HOPE CREEK GENERATING STATION
DOCKET NO. 50-354
REVISED DSER OPEN ITEM/QUESTION RESPONSES/FSAR TEXT

DSER Open Item No. 244 (DSER Section 8.3.3.3.1)**ANALYSIS AND TEST TO DEMONSTRATE ADEQUACY OF LESS THAN SPECIFIED SEPARATION**

DSER Open Item No. 253 (DSER Section 8.3.3.1.4)**COMMITMENT TO PROTECT ALL CLASS 1E EQUIPMENT FROM EXTERNAL HAZARDS VERSUS ONLY CLASS 1E EQUIPMENT IN ONE DIVISION**

QUESTION 421.10 (SECTION 7.1 & 7.2)

FIGURE 1 - TEST SETUP FOR TRAY-TO-TRAY SEPARATION

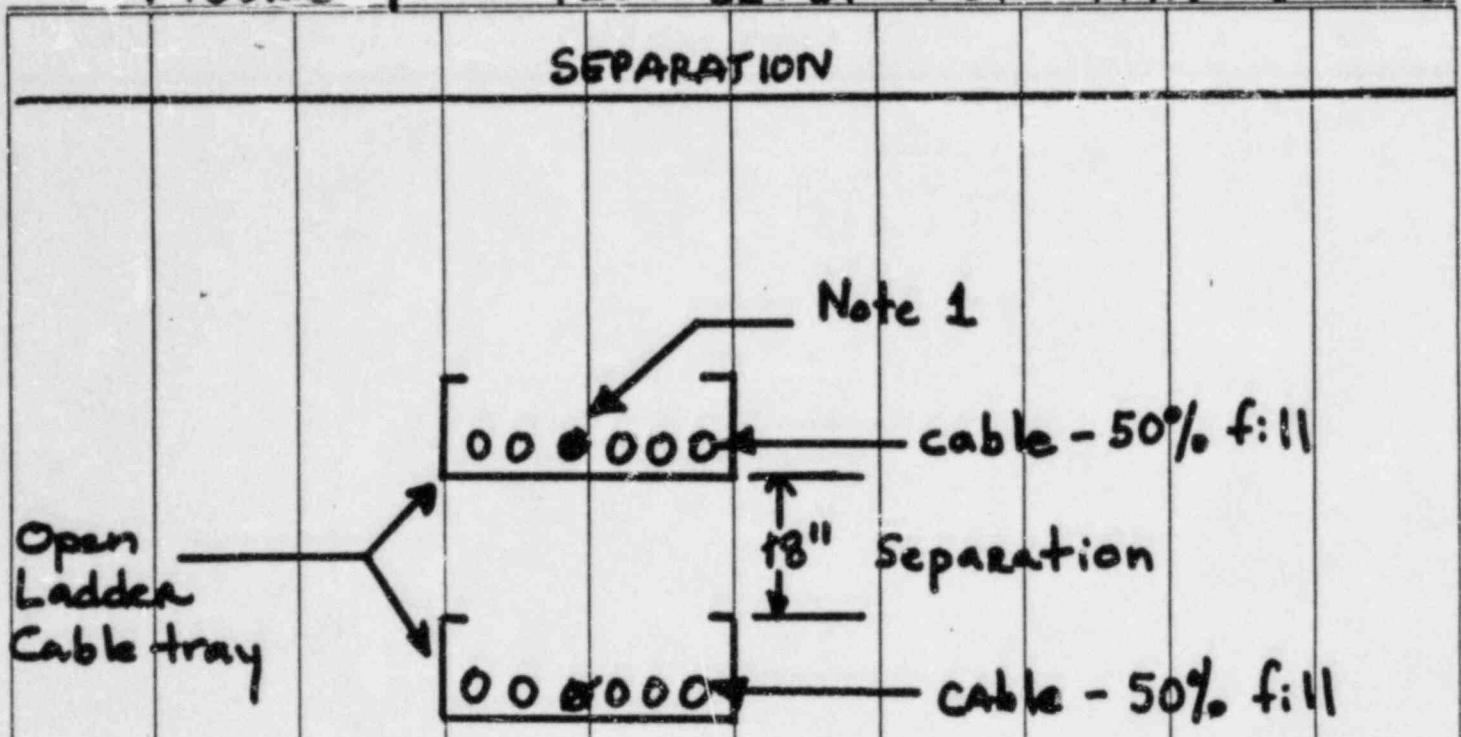
These tests shall consist of a series of tests with two vertically separated horizontal cable trays (see Figure 1). The test setup shall be identical for each test with the exception of the location of the faulted cable.

The purpose of the tests is to demonstrate the adequacy of design where two horizontal cable trays are physically separated by eighteen inches vertically when an electrical fault occurs in the lower cable tray.

The test specimens shall be placed in the cable tray assembly as shown in Figure 1. This apparatus shall be assembled to the indicated dimensions. The following guidelines shall be observed with regard to the materials and construction of the cable tray assembly:

3. The upper and lower cable trays shall be filled to a 50% fill level (by area) using an assortment of six ft unpowered control and instrumentation cables from PSE&G stock.
4. One energized 2/C Size 16 AWG cable and one energized 3/C Size 14 AWG cable shall be placed inside the cable trays that do not have the faulted cable. The energized "target" cables shall be located in the worst case locations (directly above, underneath or next to the faulted cable) as shown in Figure 1. (NOTE: Figure 1 shows the fault and "target" cable locations for the two tests).

FIGURE 3. TYPICAL FAULT CABLE CONNECTIONS

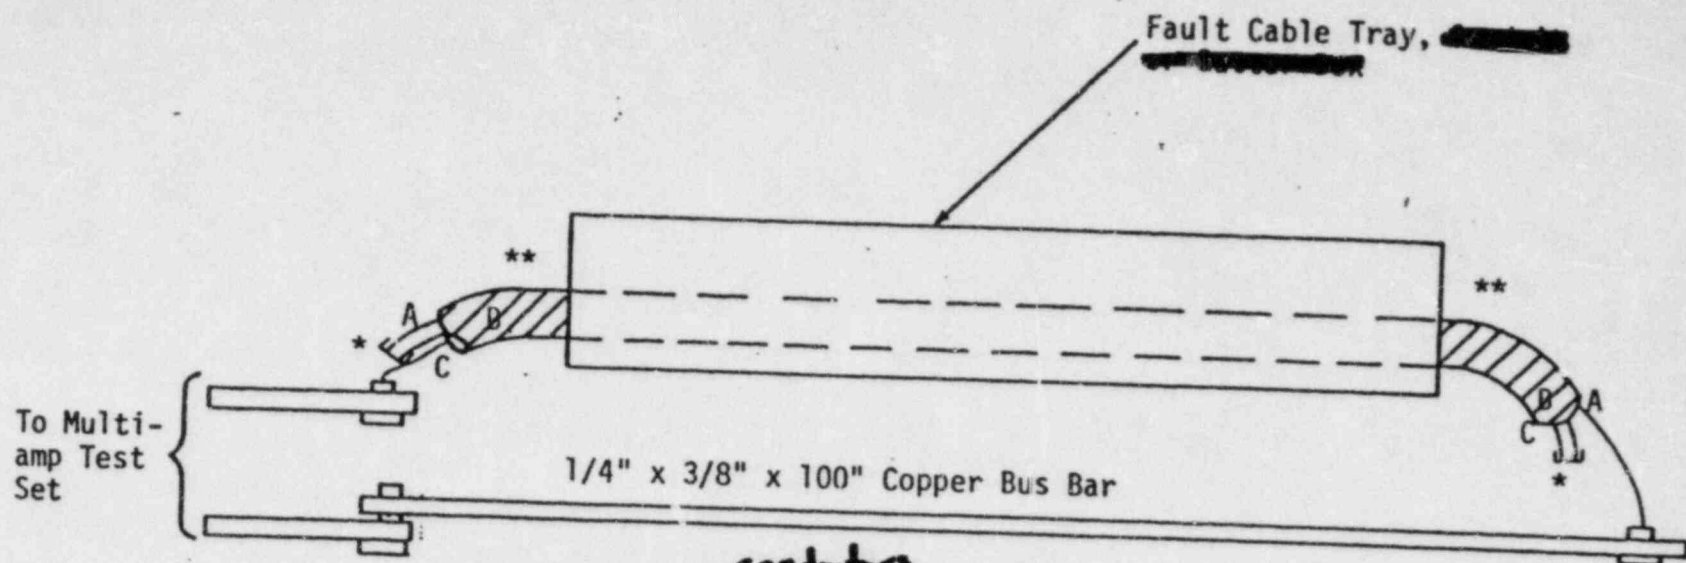
1. Connect the worst case cable (WCC) size to the copper bus bars per Figure 3.
2. Energize the two 3/C Size 14 AWG cables with 120 VAC and 15 amperes.
3. Energize the two 3/C Size 12 AWG cables with 120 VAC and 90 amperes.
4. Energize the worst case cable size with rated current (90 amps).
5. Record "target" cable voltages and currents and the fault cable current.
6. Allow the worst case cable size to conduct rated current for 15 minutes.
7. Increase the Multi-Amp Test Set output to 660 amperes in increments of 50 amperes. Hold at each level until cable failure occurs or until thermocouple readings stabilize.
8. Record "target" cable voltages and currents and the fault cable current and temperatures.

* The three ~~phases~~ ^{conductors} of the fault cable shall be connected in series.

** The fault cable shall be wrapped with a single layer of siltemp wide tape No. 65 from the edge of the test area to the bus bar.

FIGURE 1 - APRM Panel Assignment

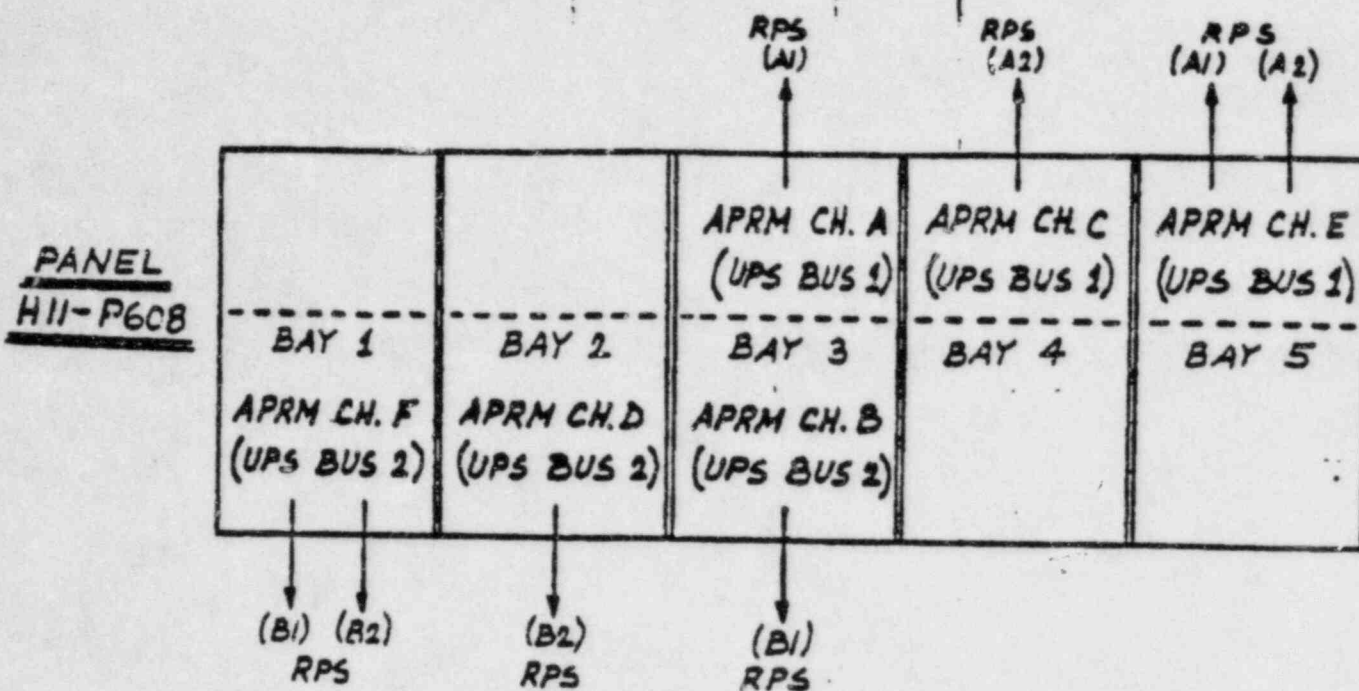
Figures 1 and 2 depict schematically the physical arrangement of the equipment in NMS and PRMS panels H11-P608, H11-P635, and H11-P636. The designs of these panels are similar to those of NMS and PRMS panels used in several BWR plants accepted by the NRC.

The layouts of the panels and the assignments of specific RPS trip logic circuitry provides the designs with the required tolerance to postulated single failures. The worst-case single failure would be the loss of any combination of trip signals within one bay of any panel. However, the loss of any bay and its associated wiring would not prevent a scram. A valid scram signal would be transmitted via the other bays because of the redundancy in the panel designs and the interconnections to the RPS (see Figure 7.1-1 of the HCGS FSAR).

FIGURE 3 - APRM/RPS Signal Separation

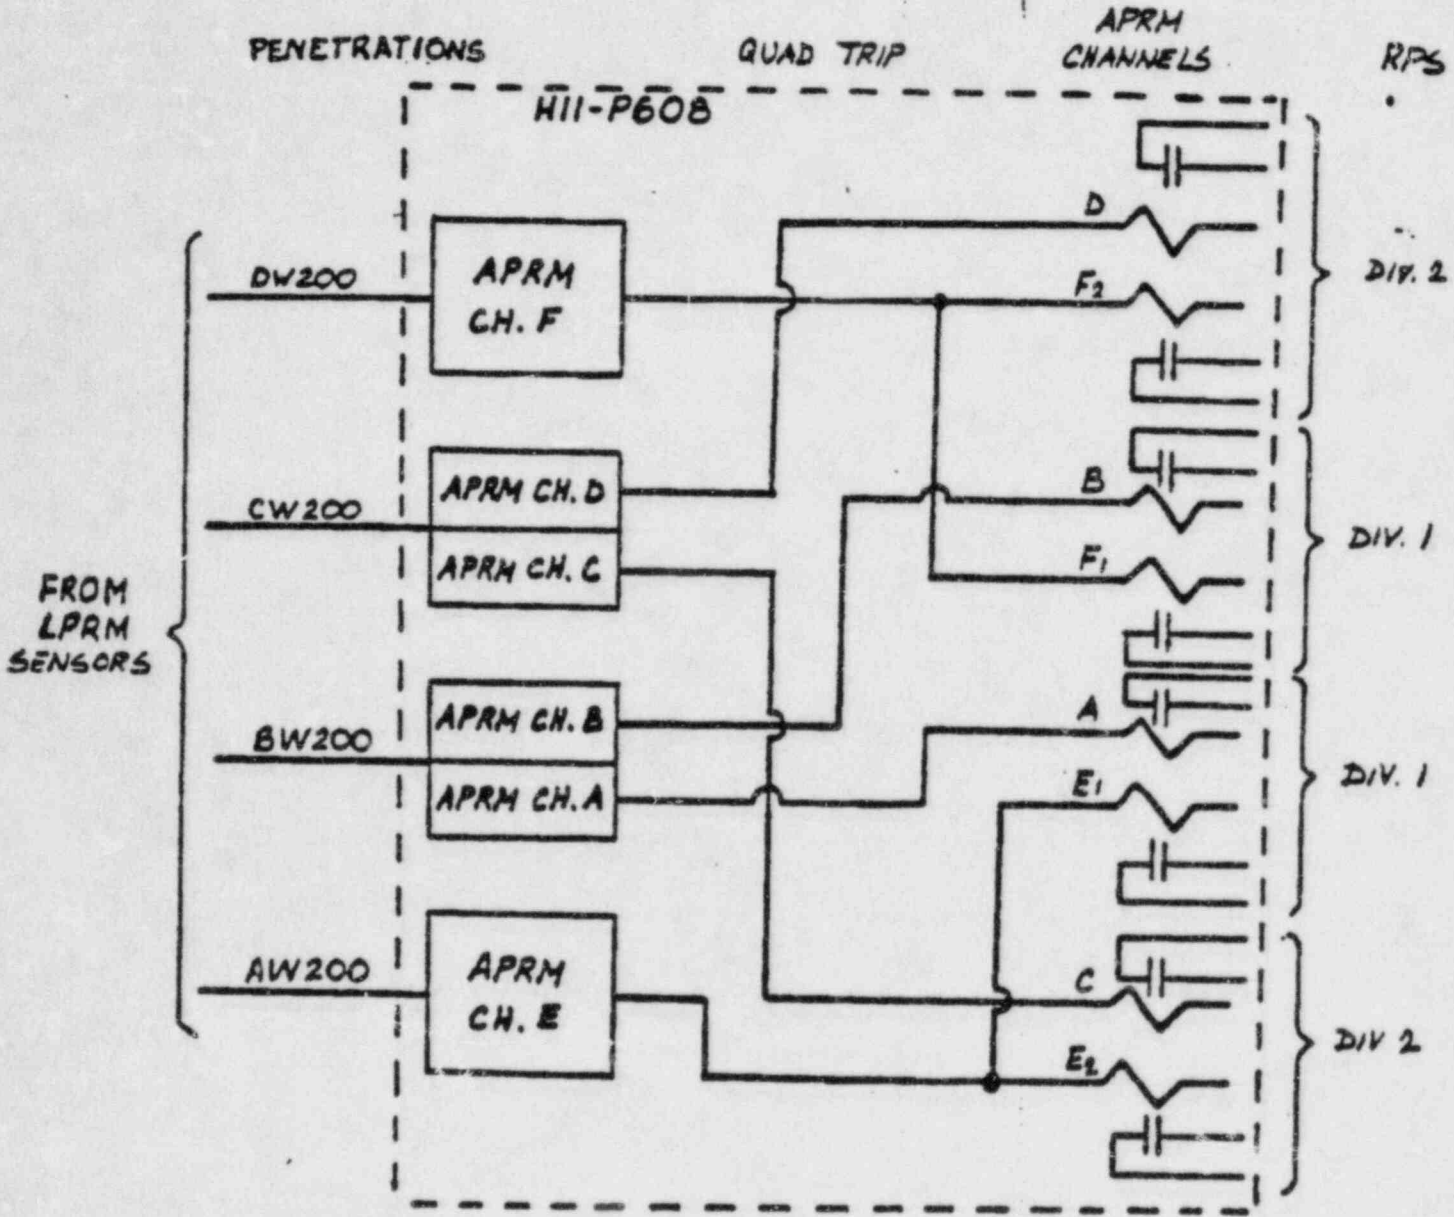
As shown in Figure 3, the isolation/separation precludes the propagation from outside the NMS cabinets^{of} failures that could cause the loss of any safety function.

FIGURE 4 - IRM Channel A

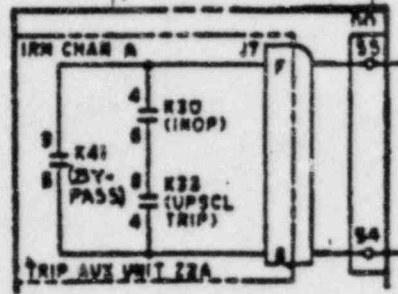
The logic circuitry for the NMS and PRMS scram trip signals conforms to the single-failure criteria. The contact configurations and failure consequences associated with IRM A (see Figure 4) and APRM A (see Figure 5) are typical of the other trip channels and are described in what follows.
